REV B Changes:

Macris Industries LED Driver	Engineer:TMS
TITLE: MI_LED_Driver_B	Author:TMS
Document Number:	Rev: A
Release Date: December, 2013	Sheet: 1/1

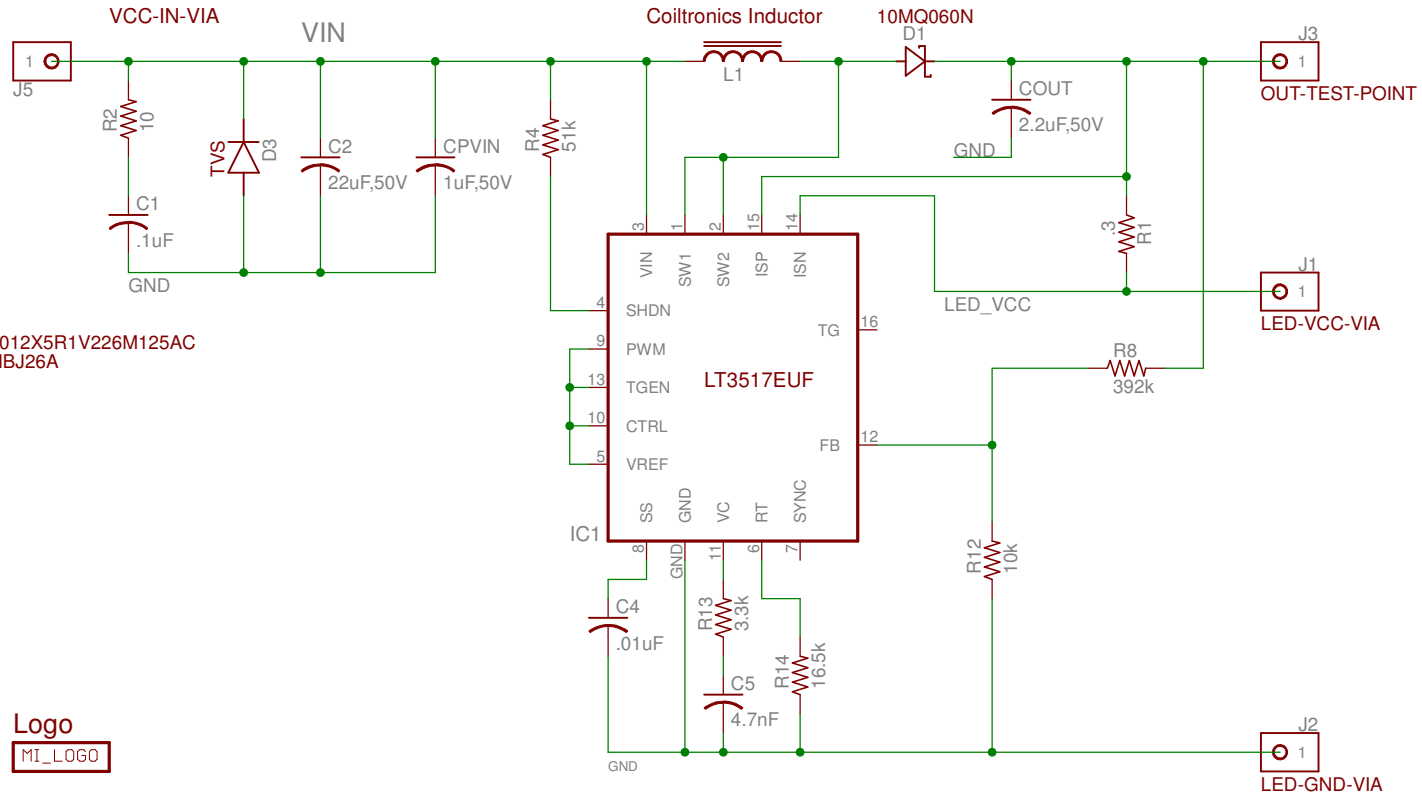
R11 was removed from the PWN, TGEN, CTRL and VREF pins
TVS was added to VIN
VIN was changed to Through Hole, no more pads for daisy chaining
Sync test point removed
Logo Added
New Inductor replaces old one
4 Layer Board, Inner layers are GND
Added RC circuit to VIN
